## **AGENDA ITEM 4A**

**Conditional Use Permit for a totally enclosed,  
automated and conveyor-style car wash – Olympus  
Pines – Lot 5 Val Vista Replat One, located at 10779  
Hillcrest Plaza**

**CITY OF LA VISTA  
PLANNING DIVISION  
RECOMMENDATION REPORT**

CASE NUMBERS: PCUP23-0001;

SHEET  
 C2.0

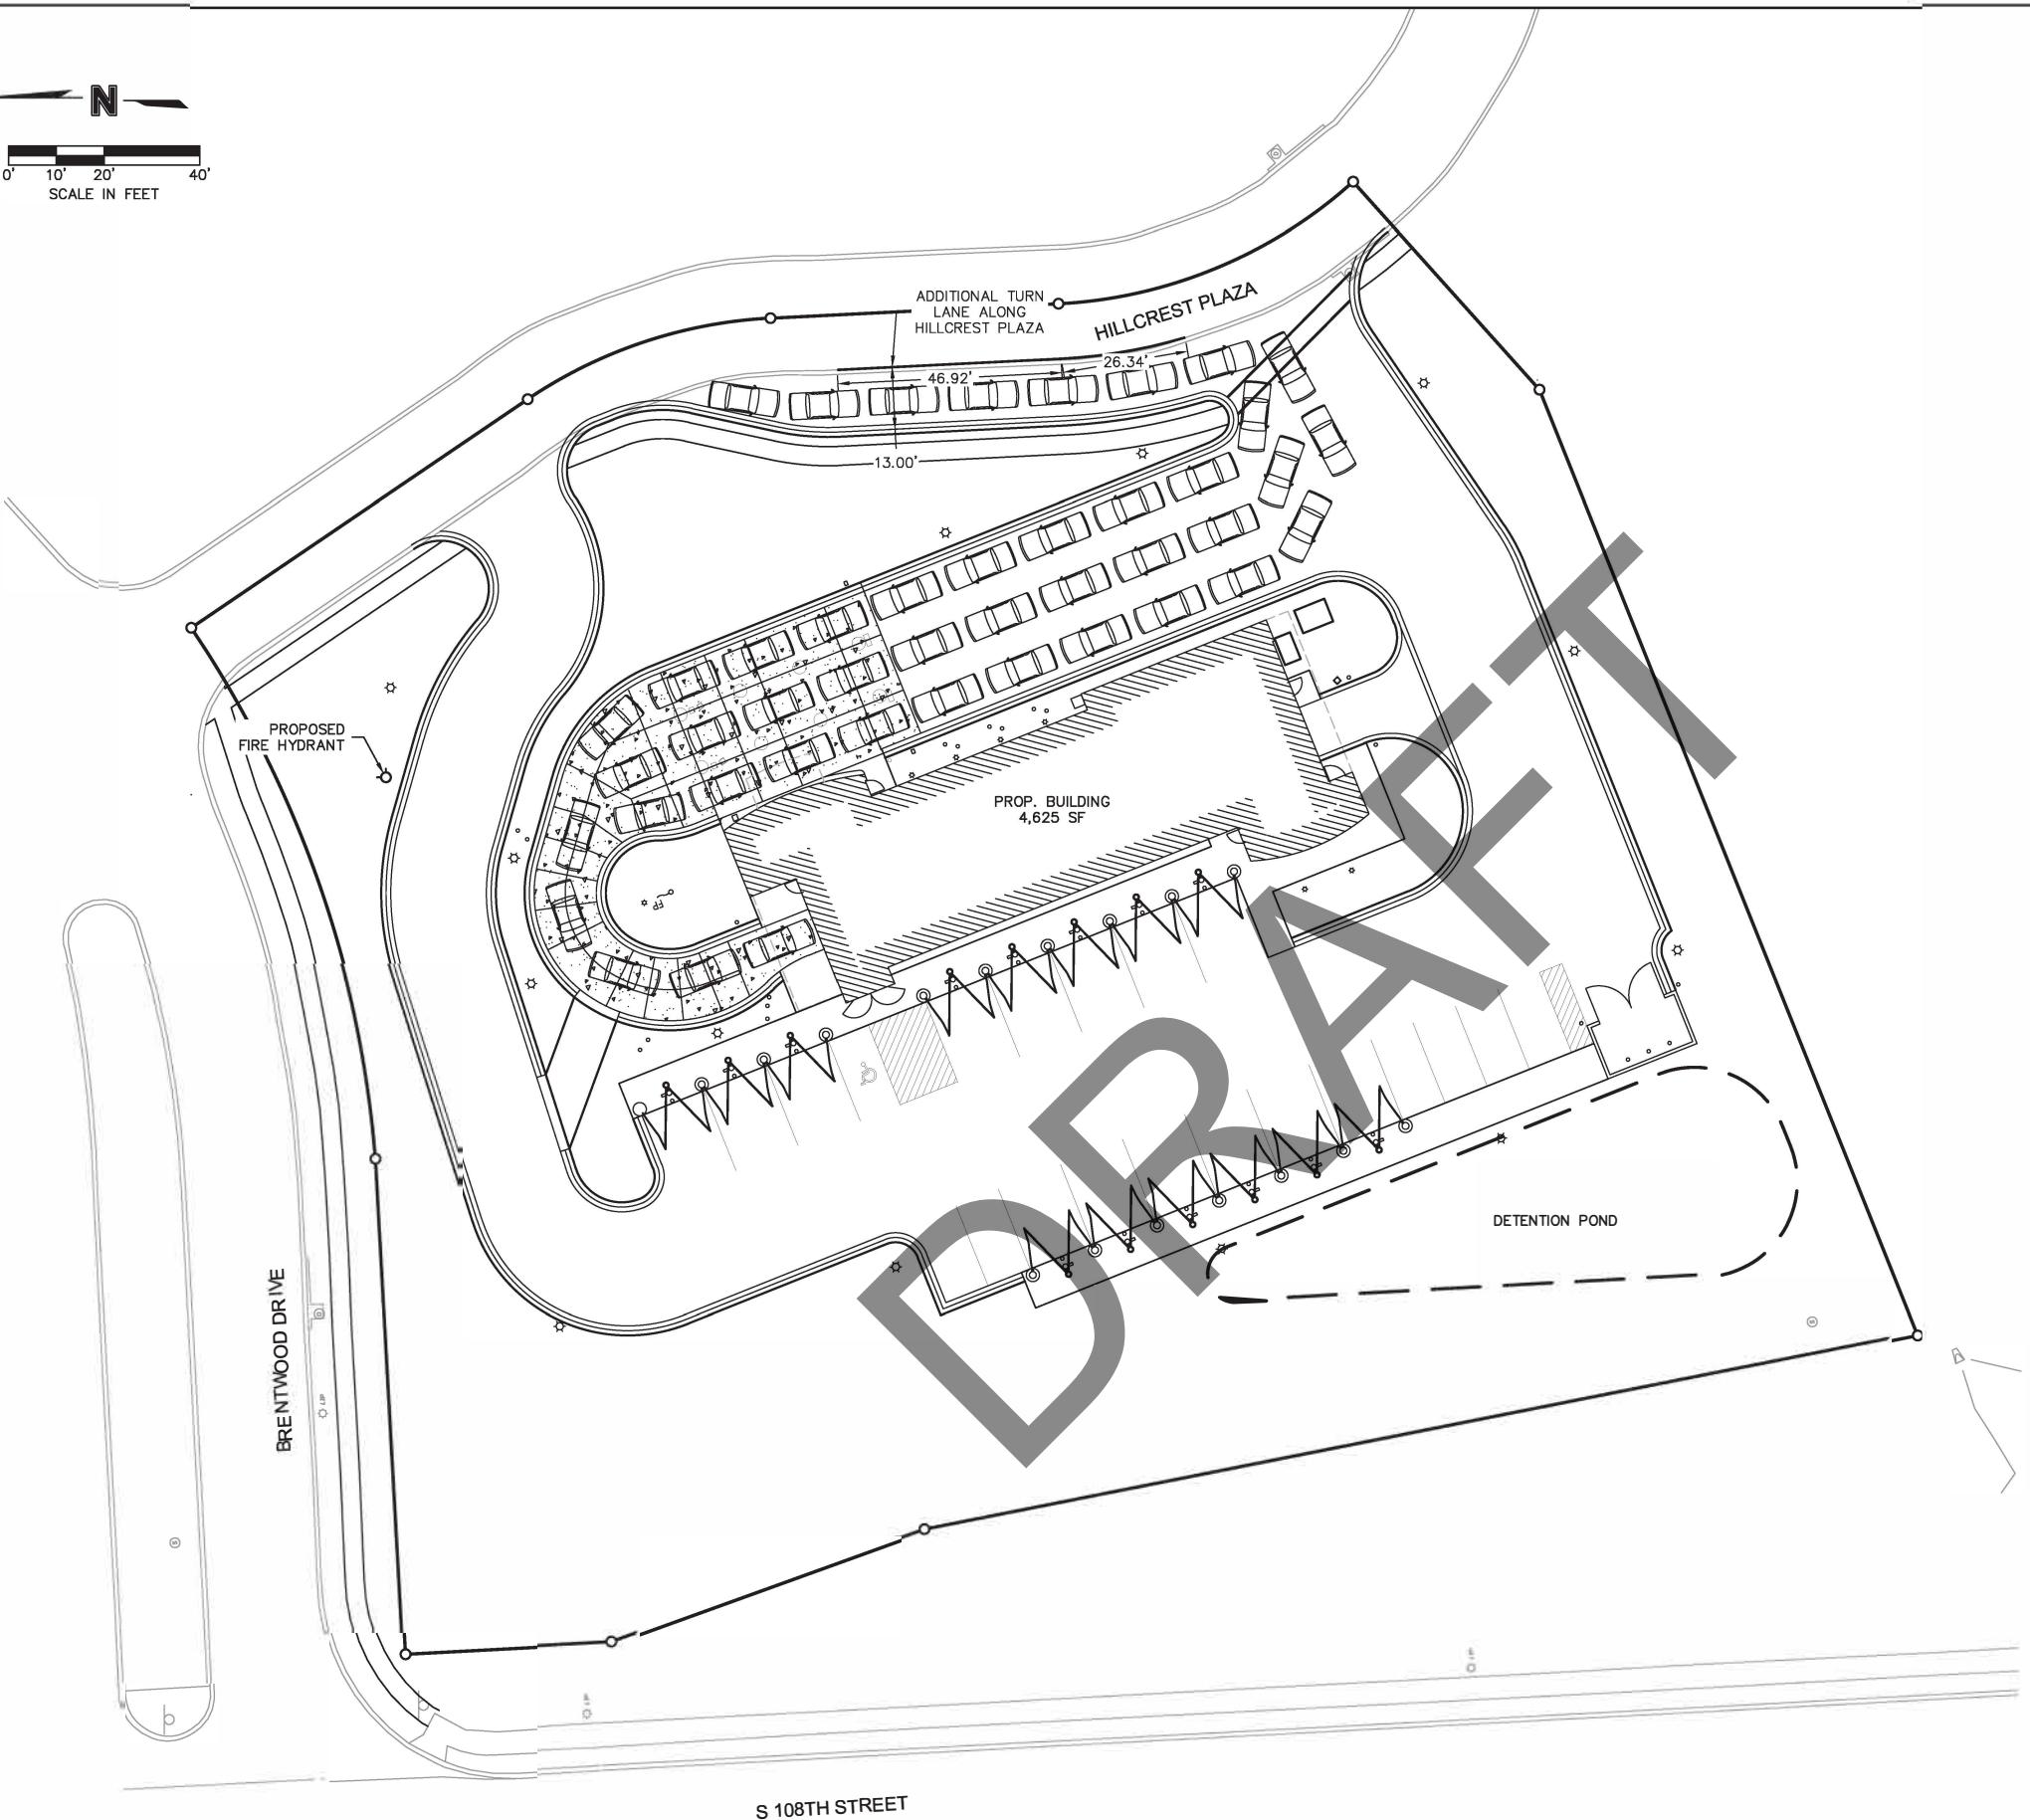
5. There are currently no fire hydrants along Hillcrest Plaza to serve this development. Private fire hydrant(s) will need to be installed. Please include hydrant locations on the site plan or on an additional exhibit.

7. Sidewalks will be required both along Brentwood Drive and Hillcrest Plaza. Please revise the site plan accordingly to represent the required sidewalks.

8. Per Section 5.11.06, the front yard setback for permitted conditional uses in the C-2 Zoning District is 25 feet, or 50 feet with the presence of parking. The "front yard" for this property includes S 108<sup>th</sup> Street, Brentwood Drive, and Hillcrest Plaza, per the definition of Front Yard depicted in the image after Section 2.07.276 of the Zoning Ordinance. It does not appear that this would cause any conflicts with your building location, however, please update the site plan to accurately reflect the proper setbacks (25 feet along Brentwood Drive, and 50 feet along 108<sup>th</sup> Street). When a property line is within a street or drive, the setback should be measured from the back-of-curb.

1. Please see attached updated operating statement
2. Please see attached updated operating statement
3. Please see attached updated operating statement
4. Please see attached updated site plan

5. Please see attached updated site plan
6. Please see attached building elevations
7. Please see attached updated site plan
8. Please see attached updated site plan

# Noise Map with Sound Mitigation Barrier

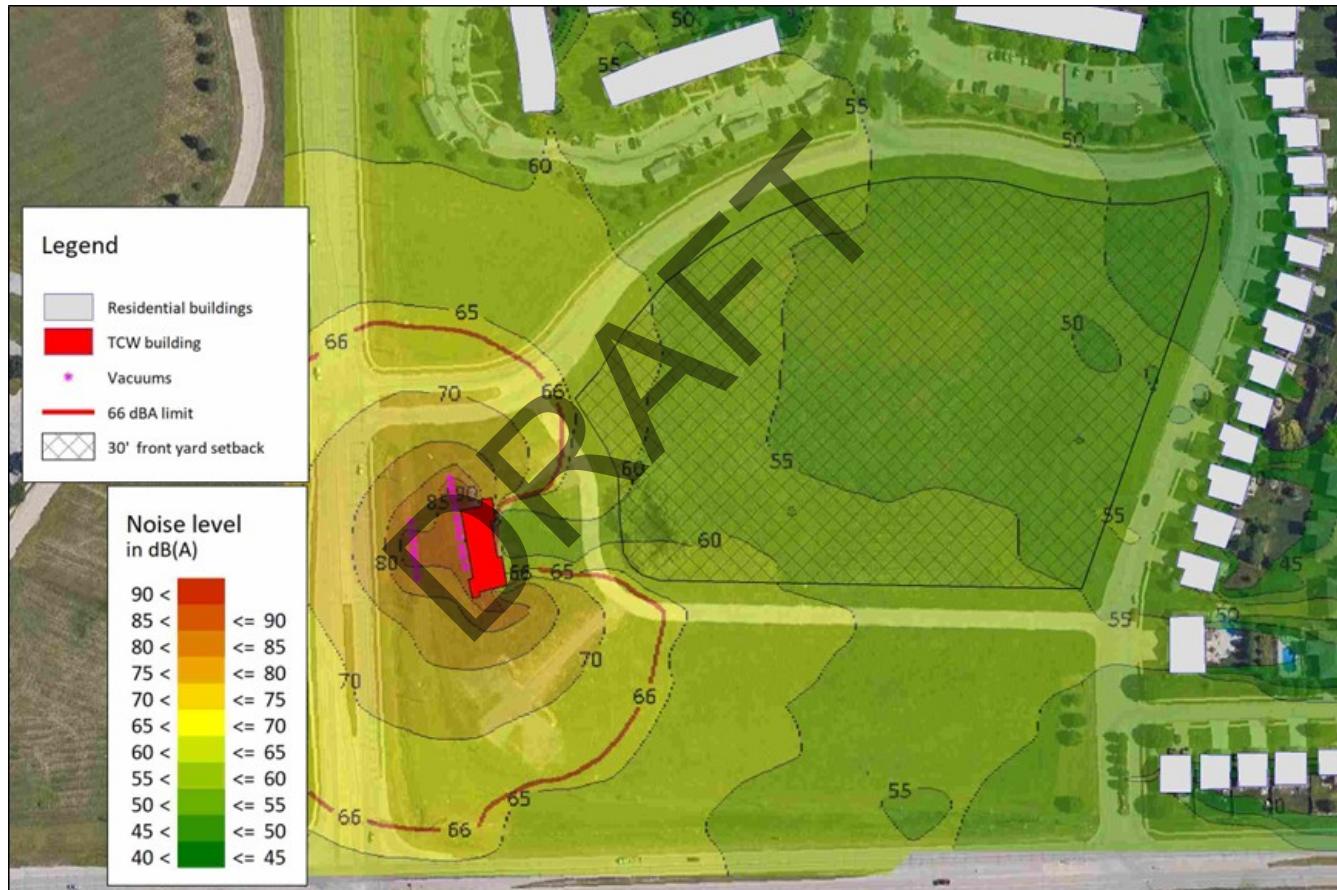
The orientation of the car wash tunnel and location of vacuums on the site also help reduce the potential negative impacts of noise. The loudest area for this model of car washes is the tunnel exit as the machinery and blowers produce the most noise. The tunnel exit for this site faces south where only one commercial property is located and then Giles right-of-way. Additionally, the vacuums (also a potential area of concern) are located on the west side of the building, so the building serves to block some of the noise from the adjacent property where potential residential development could occur. The applicant has also proposed to construct a noise mitigation barrier on the southeast side of the

tunnel exit to further reduce noise pollution emanating from the machinery and blowers.

10. The level of noise that accompanies this use as a car wash operation may be an issue for future planned residential properties to the east. The calculations for noise levels that could impact the adjacent residential buildings is above generally acceptable levels. In addition, the car wash is proposed to operate until 9:00pm.

Car Wash Vehicle Queuing Available

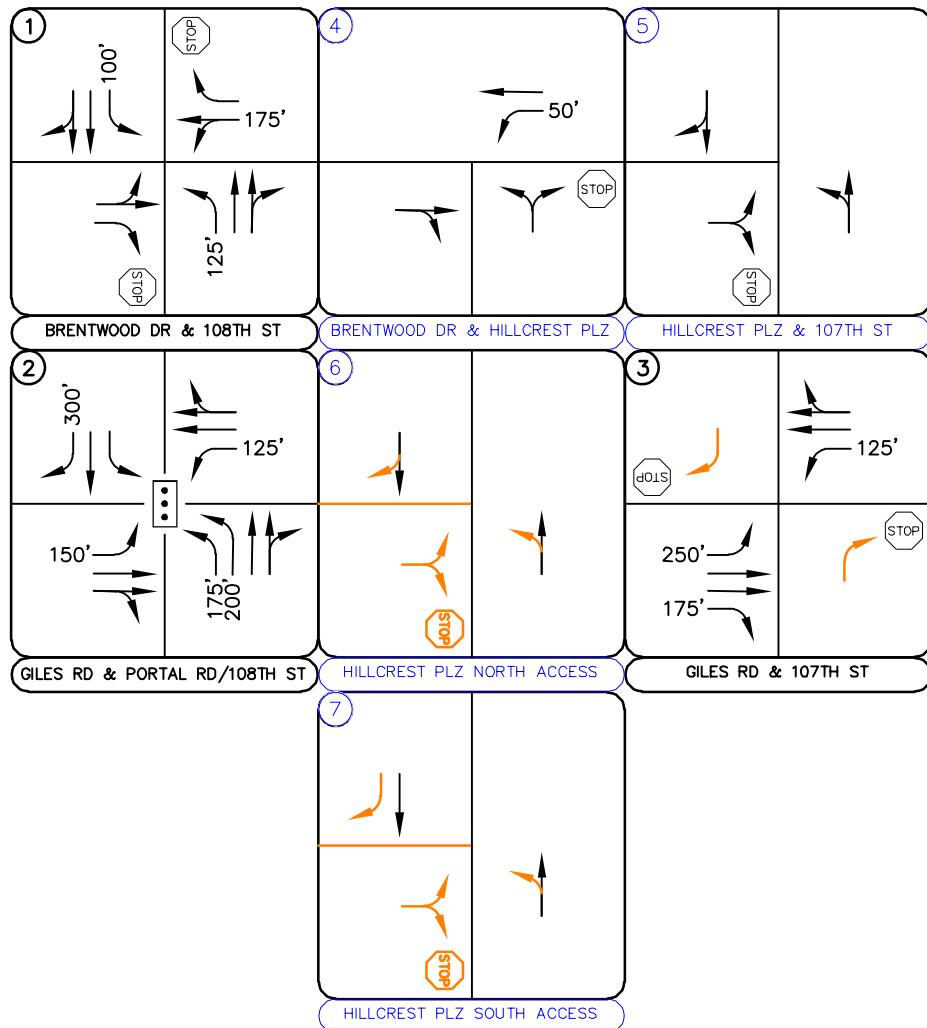
**Comment #7:** A southbound right-turn lane on Hillcrest Parkway into the Val Vista car wash should also be considered to provide added storage for entry into the north car wash and limit potential for spillback to Brentwood Drive. This would provide for vehicles destined to the Val Vista car wash and vehicles to the other car wash could then bypass queued Val Vista car wash customers. This is illustrated in the following graphic. This may require modification to the site layout to accommodate turning template into the site.

**Response:** A southbound right turn lane will be provided at the entrance access along Hillcrest Plaza.

However, if stacking ever becomes an issue and vehicles stack further past the southbound right turn lane into the site, then alternative routes will be implemented. The south access (entrance) will be closed off by temporary barricades to reroute entering vehicles to the north for vehicles to be able to stack around the south side of the building in a counterclockwise direction. A site plan snip of this temporary operation is shown below:
